Review of Hydrogeological Report on Site F – Burlington, Proposed Landfill Region of Halton

**David Estrin, Barristers and
Solicitors for the Town of Milton**

1987 November 09

Review of Proposed Landfill Sites D and F, Region of Halton

FIGURE 2
LOCAL CATEGORIZATION OF THE
QUEENSTON FORMATION
BASED ON DISTRIBUTION OF FRACTURES
 (after Trow, Ref.1)

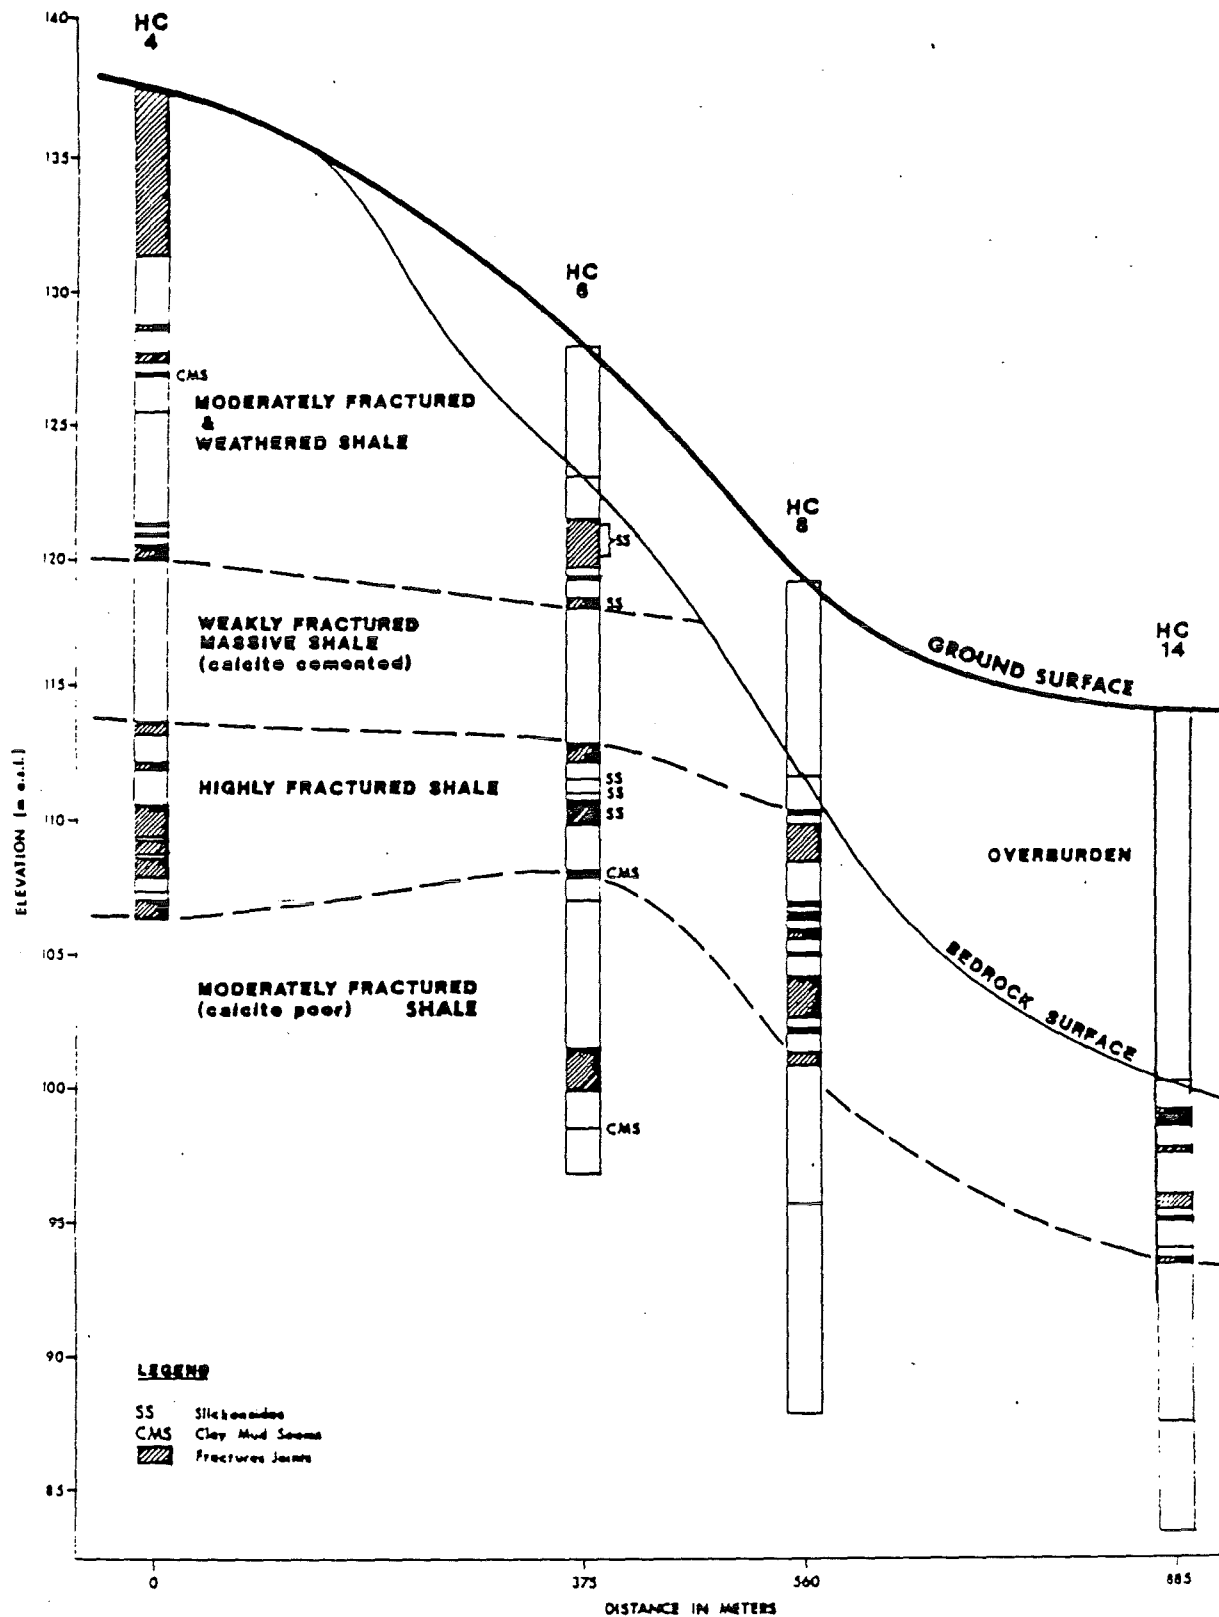
Trow present a "Local Categorization of the Queenston Formation Based on Distribution of Fractures" in which they identify four zones within the shale, as shown on their Figure 2 (reproduced here as Figure 2) and described generally by the degree of fracturing or weathering. They subsequently define the succession on a hydrostratigraphic basis and present a summary on their Figure 4 (Figure 3).

What is particularly confusing for readers of the Trow report is that they maintain the same names for the hydrostratigraphic units within the Queenston shale as they used for the categorization based on fractures. However, as was revealed in cross-examination, they have redefined the contacts, so that they do not necessarily conform to the "Local Categorization" shown on their Figure 2. It should be noted that the surficial deposits within the vicinity of the site are considered by Trow as one hydrostratigraphic unit which they sub-divided into a "Till Unit" and a "Discharge Zone Till".

As will be discussed later, we are of the opinion that Trow have presented a hydrostratigraphic classification of the shale which is too rigorous to be supported by the available data.

If there is a highly fractured zone acting as an underdrain then it would be expected that vertical gradients would be less in that zone. This suggests that, at least in the vicinity of borehole HC-6, the zone definition based on the fractures is probably more realistic.

FIGURE 3

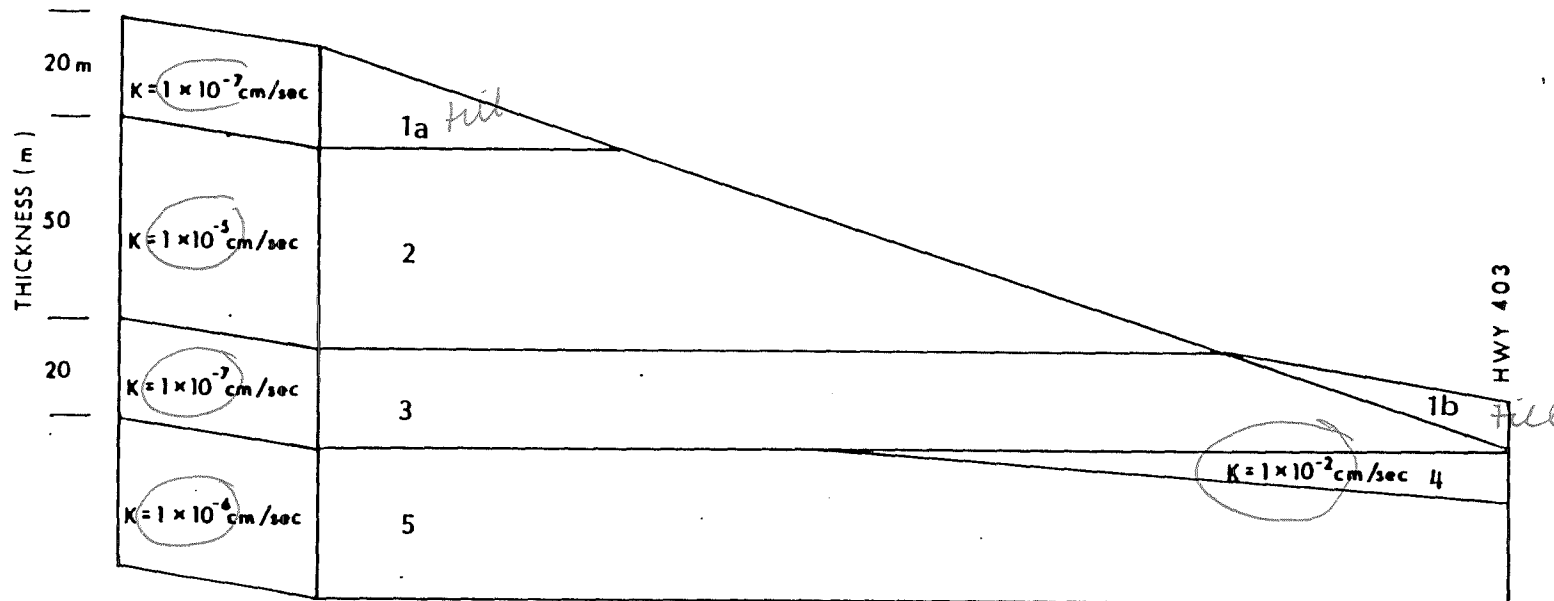
The vertical gradients do not appear to support Trow's contention that the zone which they have defined as the Highly Fractured Shale Unit is a significant underdrain to the system.

SITE F , HC-8

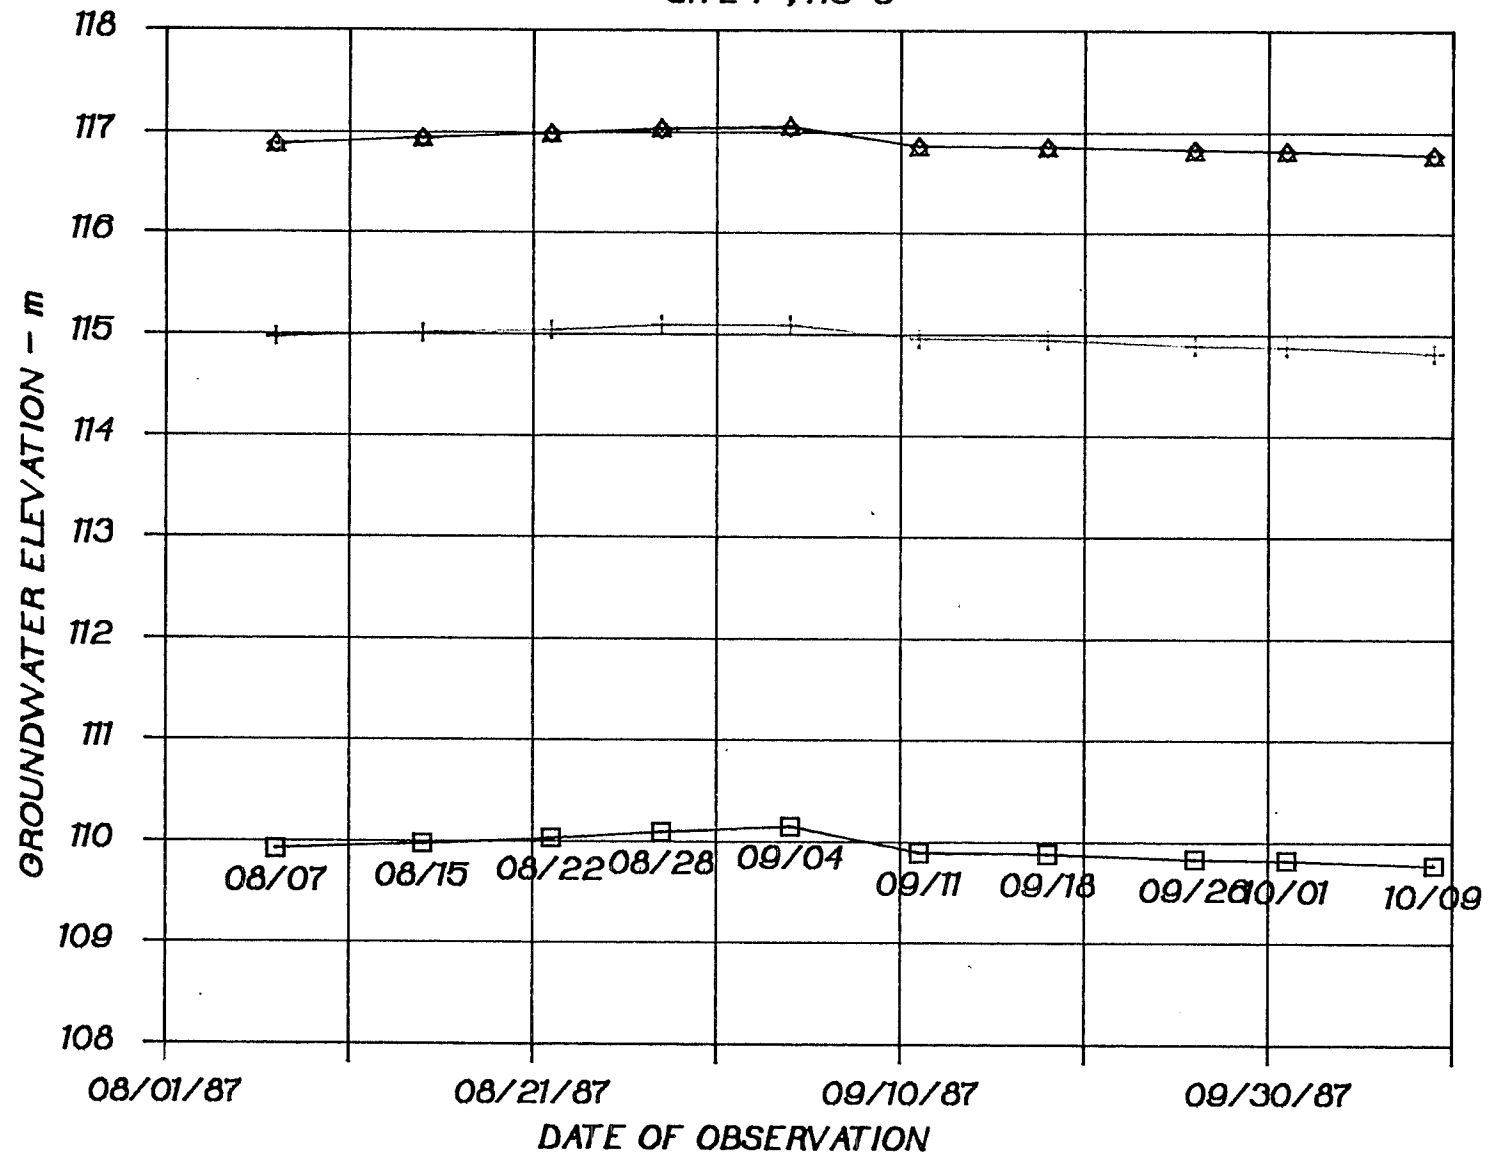
Borehole HC-8 just south of the proposed landfill has horizontal to slightly upward gradients in the upper part of the shale and downward gradients to the bottom, over the major portion of the borehole. The downward gradients appear to correspond to Trow's Highly Fractured Zone.

The pattern of vertical gradients recorded in boreholes HC-3, HC-5 and HC-8 during the present study were similar to those given by Trow. In the case of HC-6, the pattern was initially the same, although the last two readings saw the water level rise in the lowest piezometer to an elevation slightly above the water level in Piezometer No. 2. There is no obvious reason for this.

SITE F , HC-9

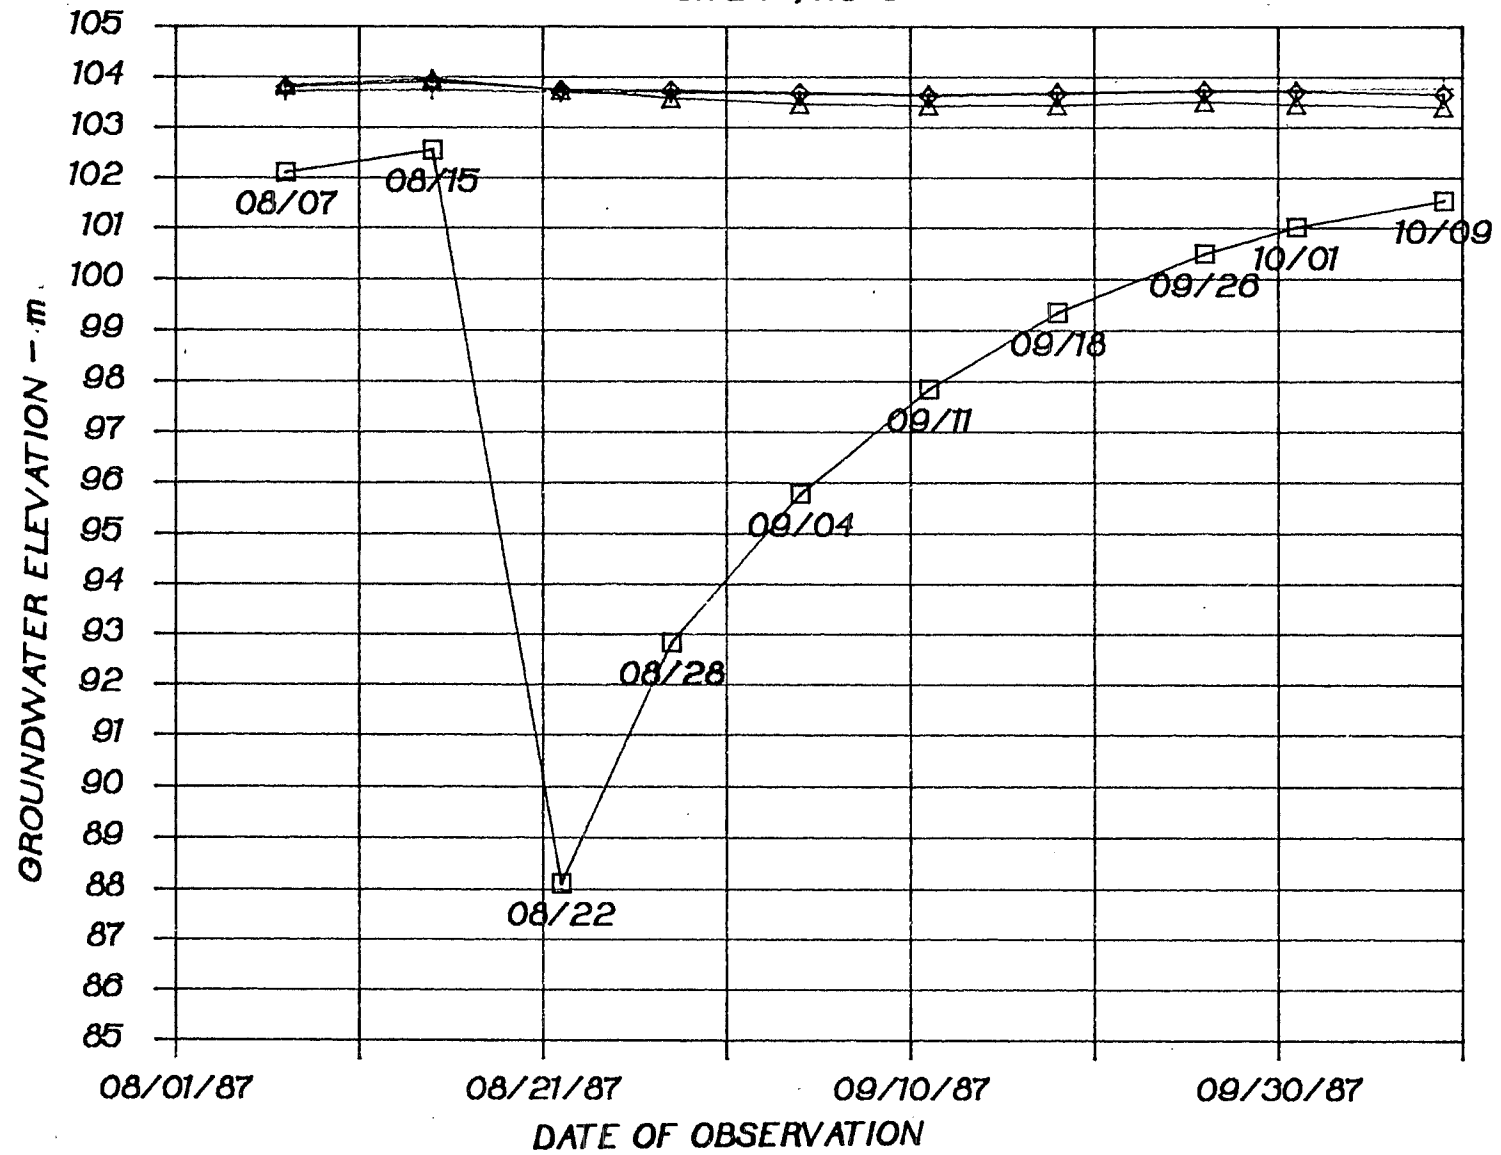
The water levels in borehole HC-9 showed a similar pattern to that depicted by Trow, with very small to non-existent gradients in the upper three piezometers and a stronger downward gradient between the two deepest piezometers. A close examination of the hydrographs for the upper three piezometers shows that the vertical gradients actually changed from being slightly downward to slightly upwards.

It can be seen from the hydrograph for the deepest piezometer (No. 4) that sometime in August someone (possibly as part of a monitoring program) removed water from the hole. After five weeks the water level had not fully recovered, indicating that this piezometer is set in a poorly permeable part of the shale.

SITE F , HC-14

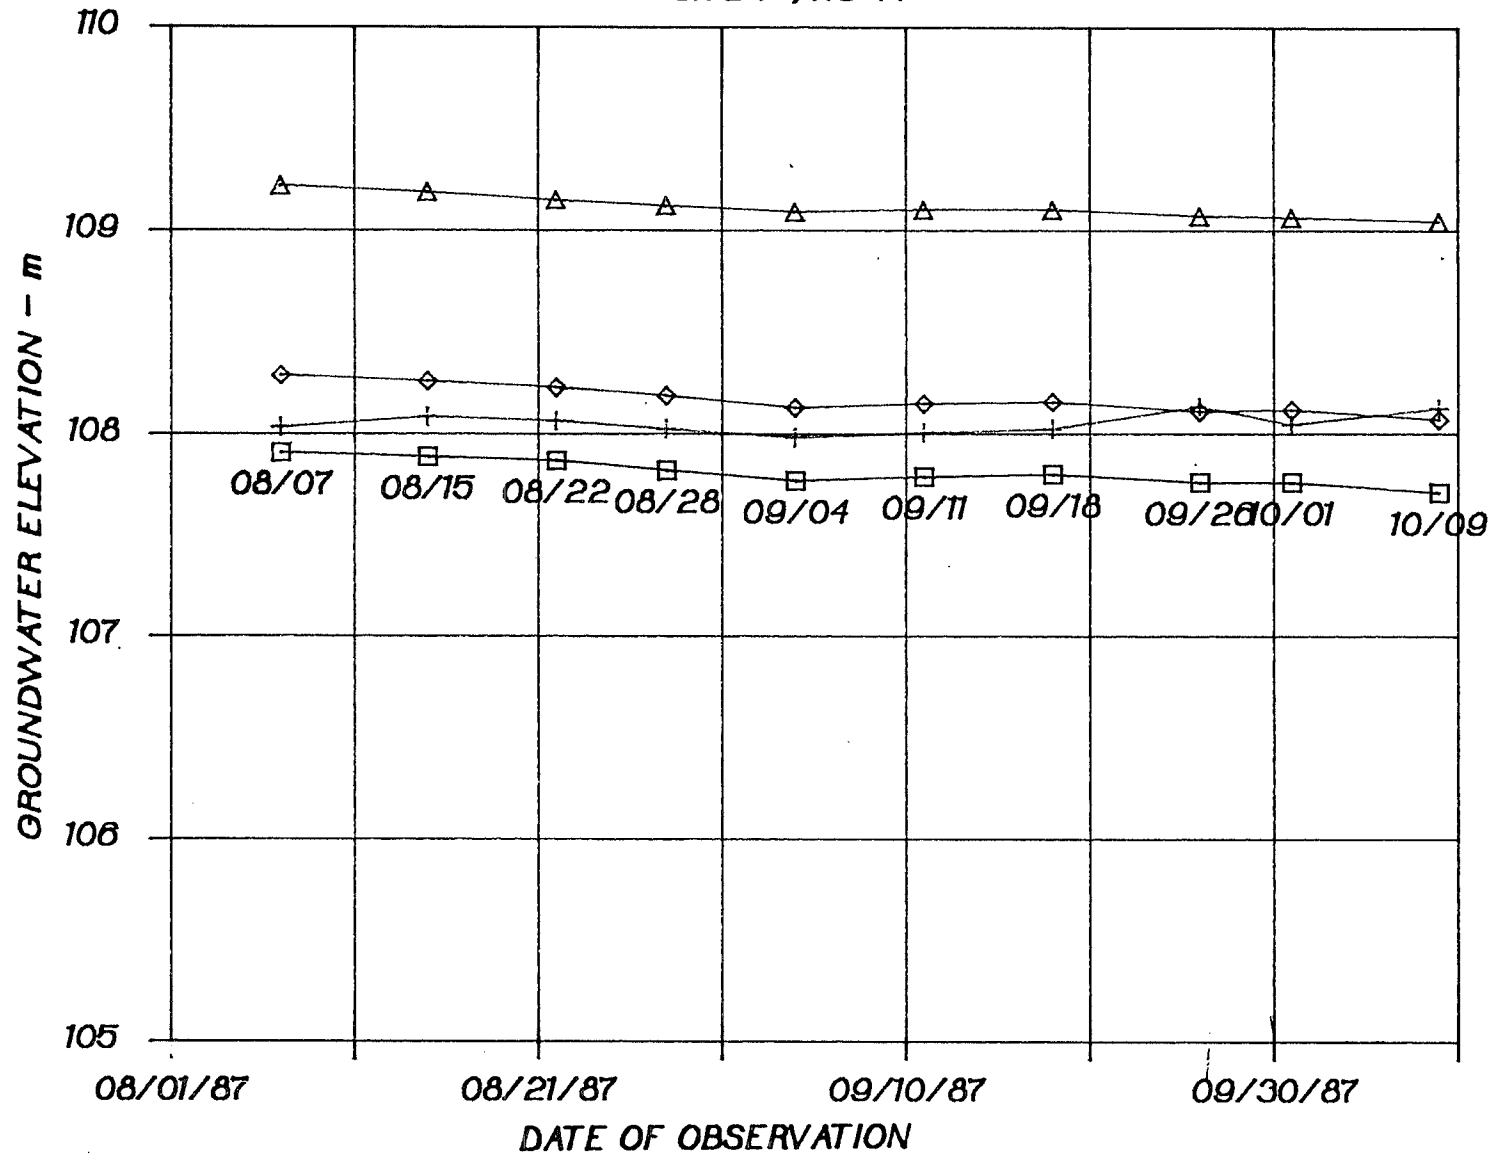
In the case of HC-14 the vertical gradients, for most of the monitoring period, were consistently downwards without the near horizontal pattern exhibited in the Trow cross-sections. However, towards the end of the monitoring period, Piezometers 2 and 3 had water levels which were essentially the same.
